# Office Action Summary

09/601,545

BREYNAERT, FRANCOIS

## **DETAILED ACTION**

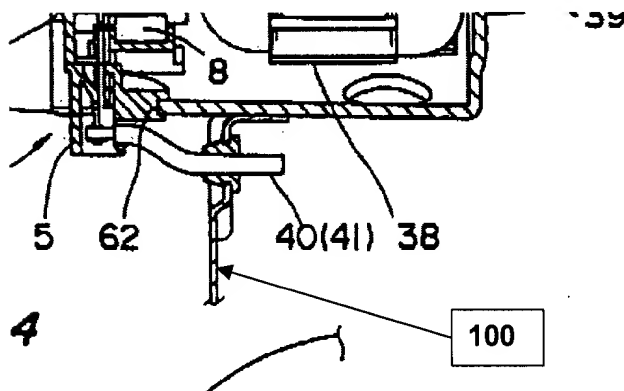
7. Takiguchi clearly teaches the construction of a noise suppression system for a permanent-magnet motor (1), in which:

the motor includes supply brushes (26, 27) connected to an external power supply by leads (40, 41), which are associated with inductors (6, 7);

and a metal casing (5), characterized in that:

each brush is connected to the metal casing of the motor through at least one noise suppression capacitor (8),

in that the metal casing of the motor is connected to the vehicle's earth, and

that the metal casing of the motor and the functional device have complementary means (100, added by the examiner) for earthing the casing.

8. With regards to claim 4, Takiguchi disclose a permanent magnet motor wherein the means for earthing the casing of the motor comprise means (100) for fastening this motor to the functional device.
